AGENDA
CITY OF TAYLOR, TEXAS
PLANNING & ZONING COMMISSION MEETING
CITY HALL COUNCIL CHAMBERS
400 PORTER STREET, TAYLOR, TEXAS, 76574
DECEMBER 10, 2024, 6:00 PM

1. Review and approve minutes from the meeting on November 12, 2024
2. **PZ-2024-2291** Consider Disapproval of the Nyle Maxwell Minor Subdivision Plat, generally located at 14150 Hwy 79, legally described as 8.010 acres of land part of the William Kincaid Survey, Abstract No. 0373, more particularly described by Williamson Central Appraisal District Parcels R311124, R019359, R331352, Taylor, Williamson County, Texas. *Courtney Peres*
3. **PZ-2024-2258** Consider Approval of the IMarket America Preliminary Plat, generally located northeast at the intersection of Carlos G. Parker Boulevard S.E. and FM 112, legally described as a 211.84-acre tract of land in the Parthinia Coursey Survey, Abstract No. 131, more particularly described by Williamson Central Appraisal District Parcels R357492, R318771, R006142, R620065, R624522, R620064, R318773, Taylor, Williamson County, Texas. *Shai Roos*

Planning Department Comments

MINOR PLAT
NYLE MAXWELL TAYLOR

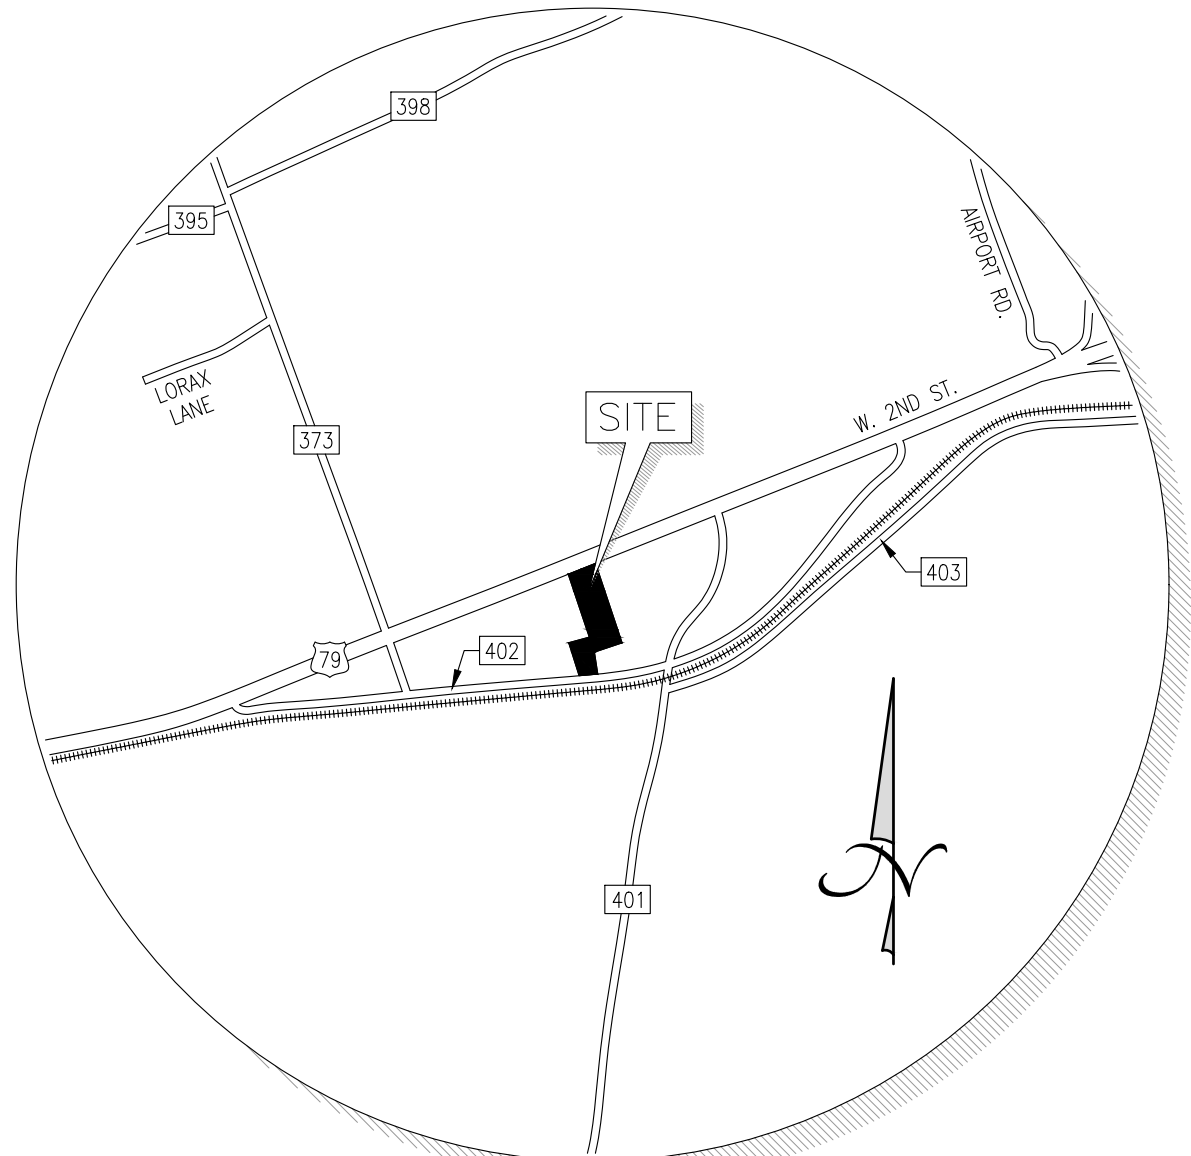
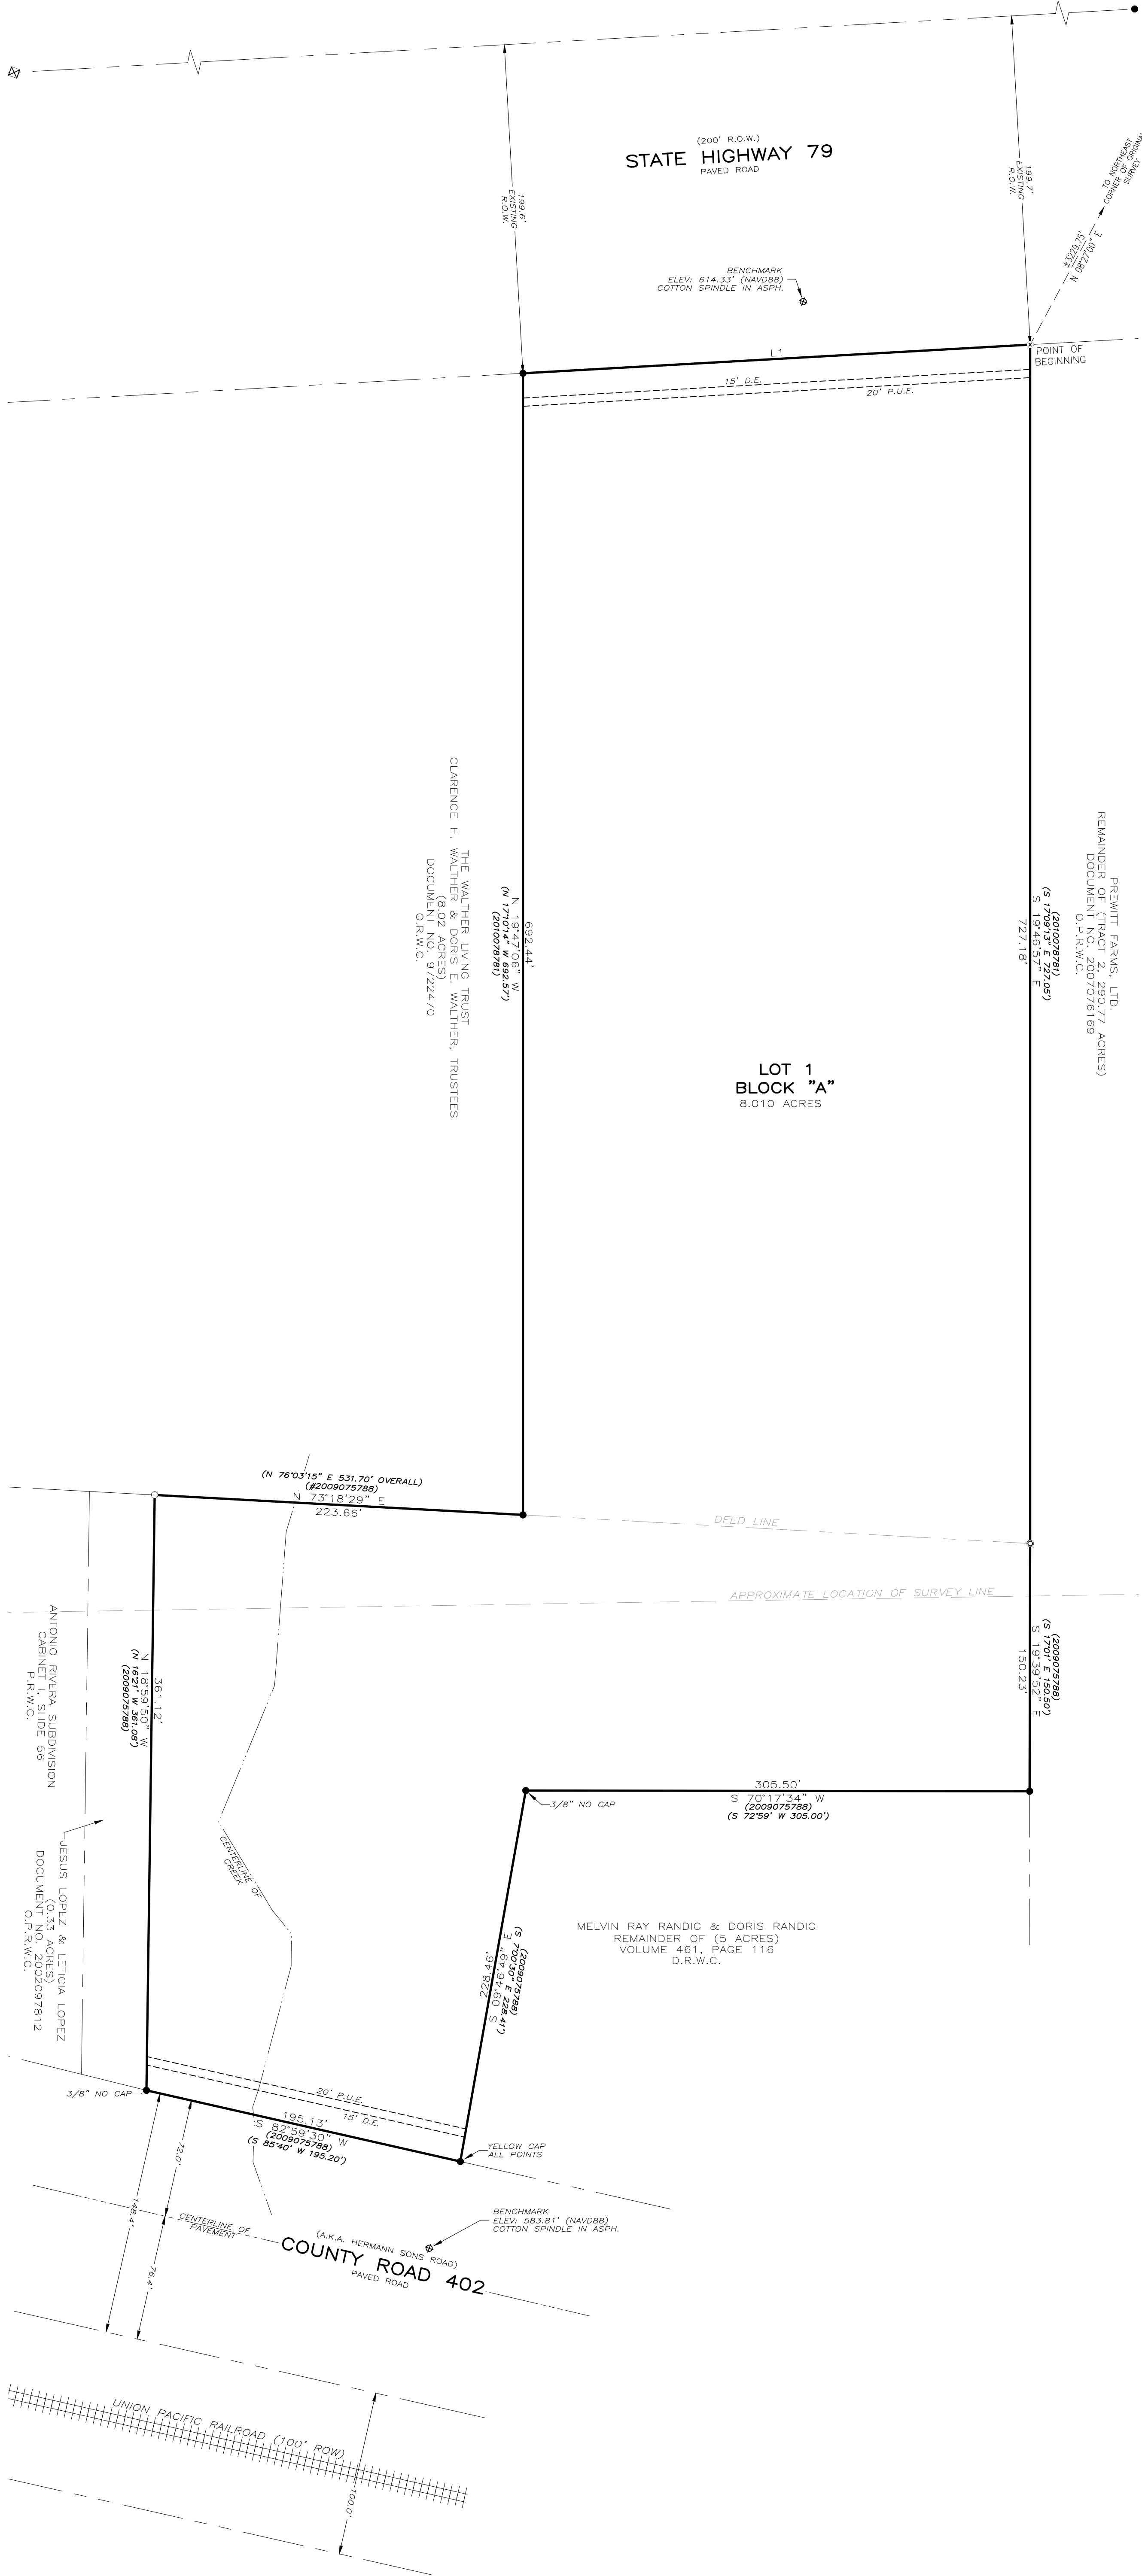
1. It is noted that the site is subject to drainage easements once plans are submitted for development. This includes but is not limited to detention and areas where existing drainage is being redirected. This will be verified in review of the site drainage any analysis of developed conditions.

GRADIANT TECHNOLOGY PARK PRELIMINARY PLAT

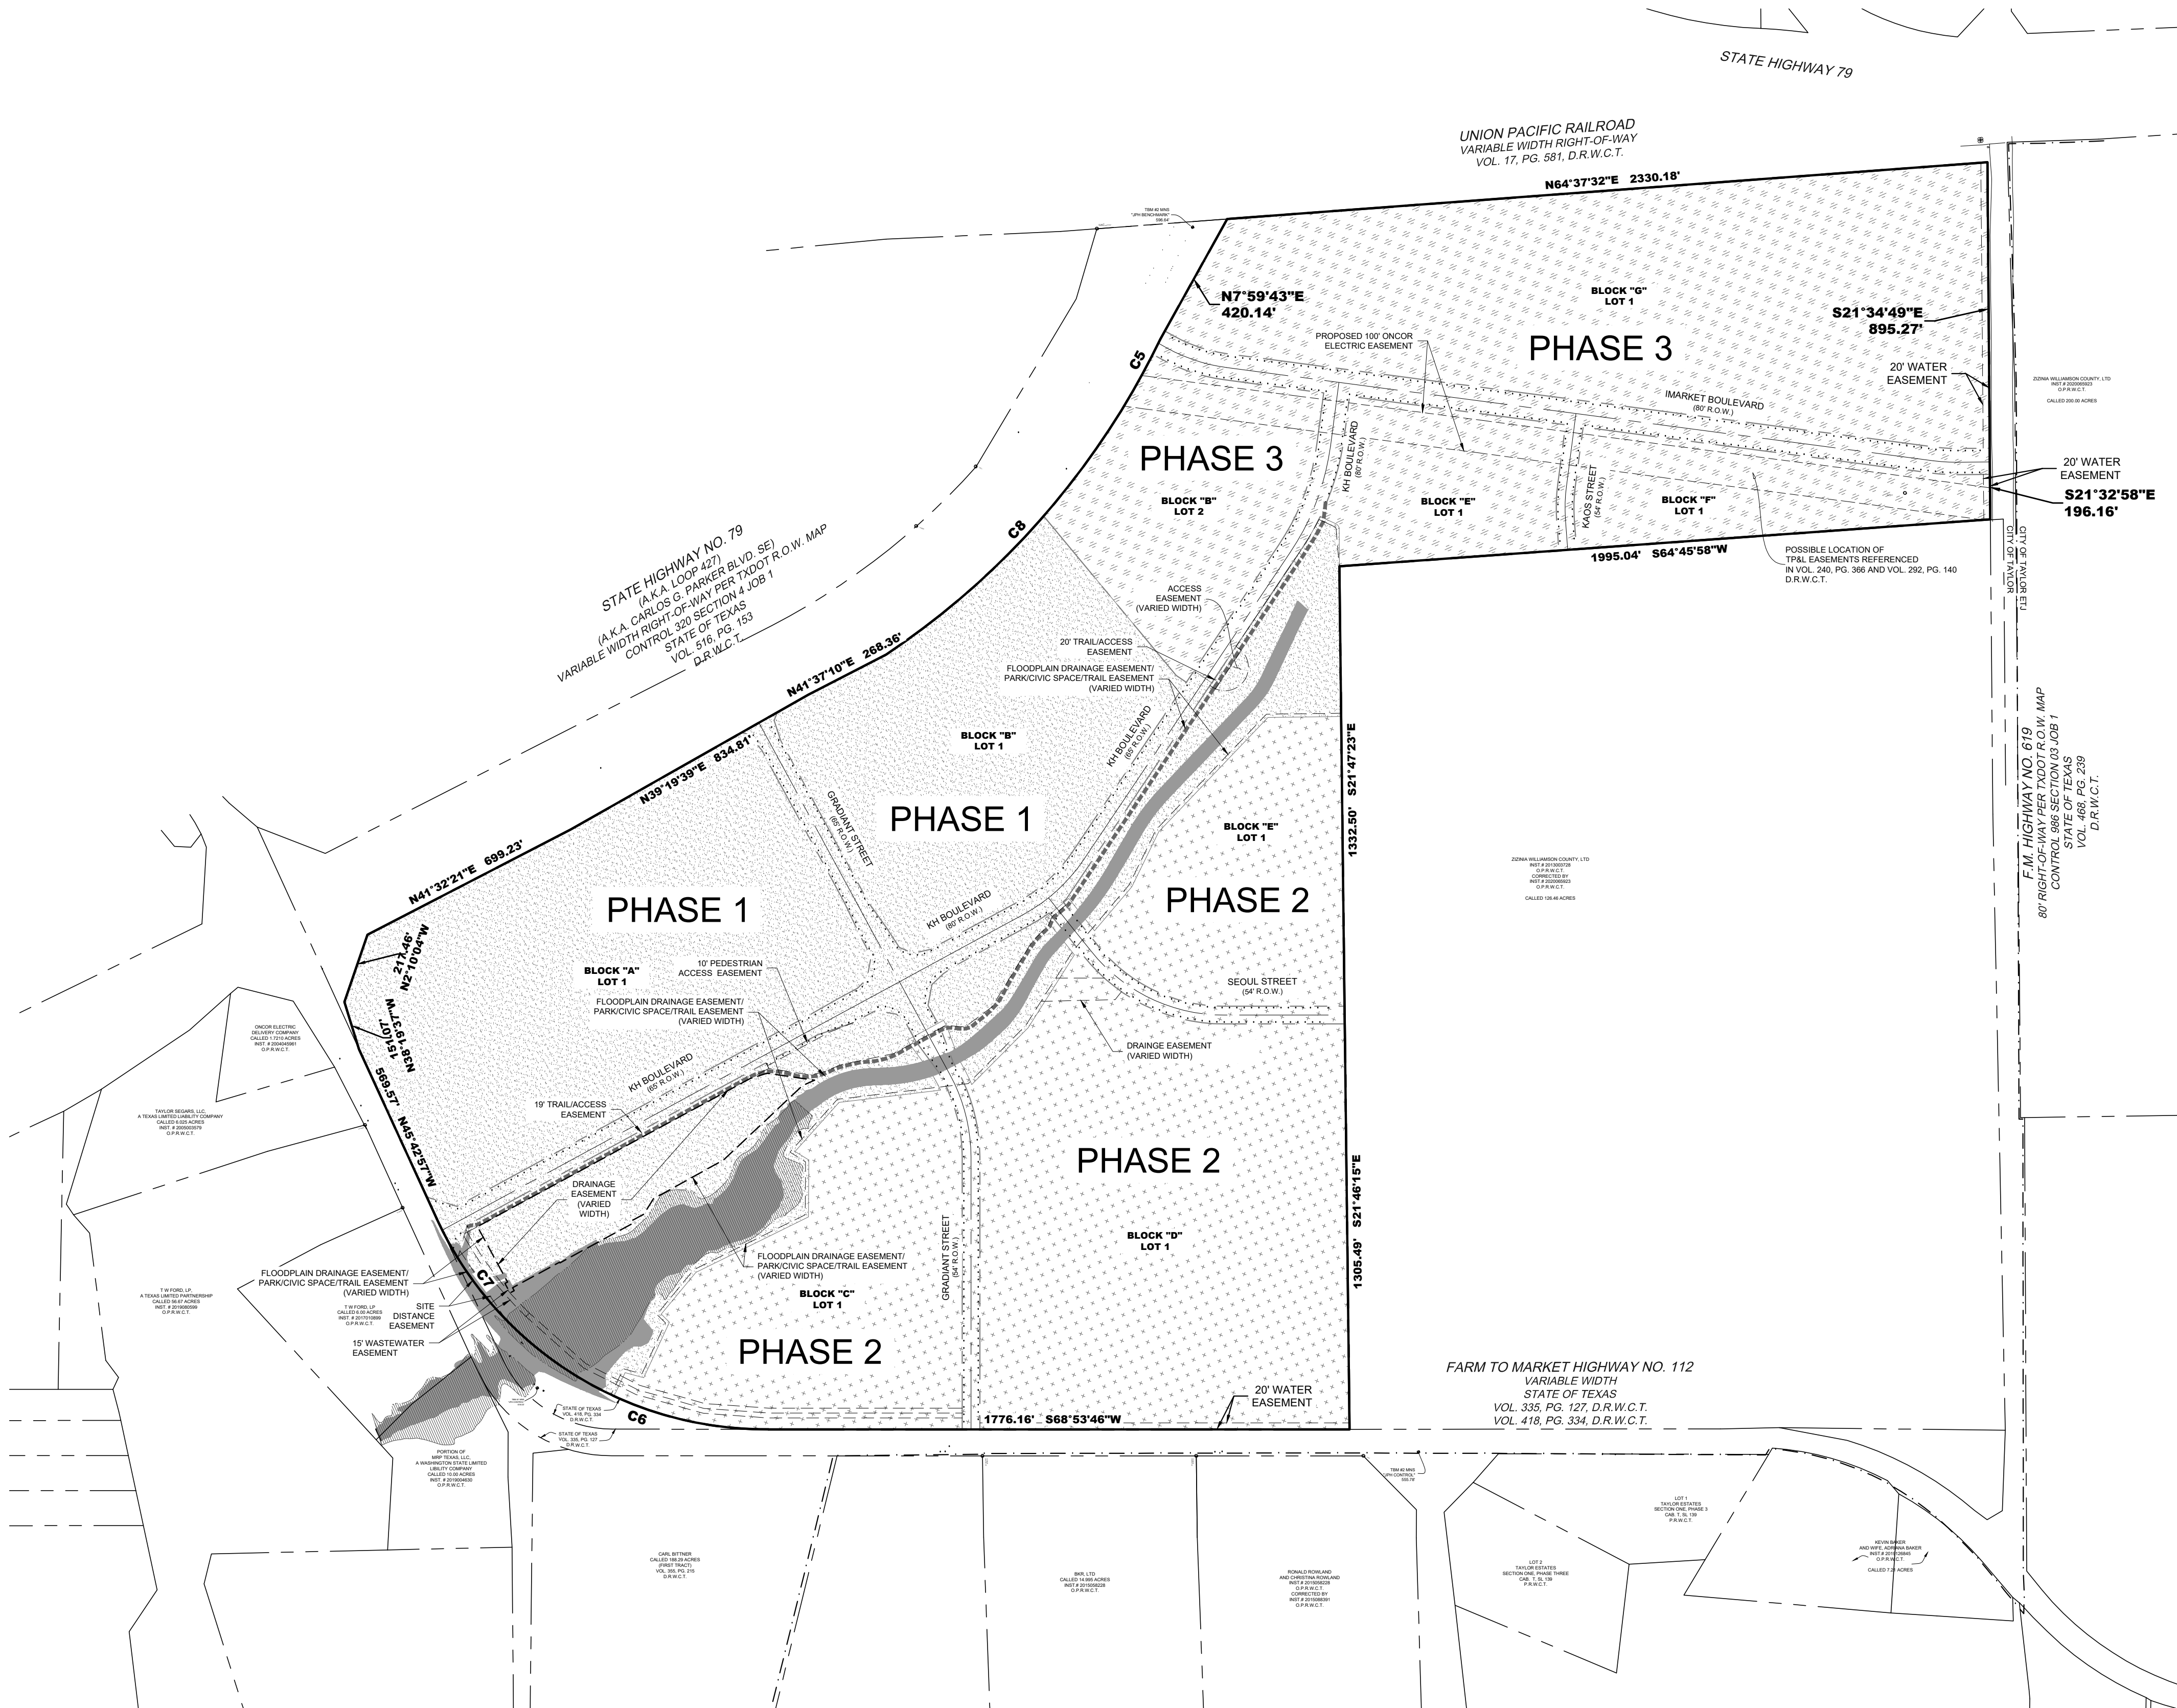
Provide sheet title for phasing plan
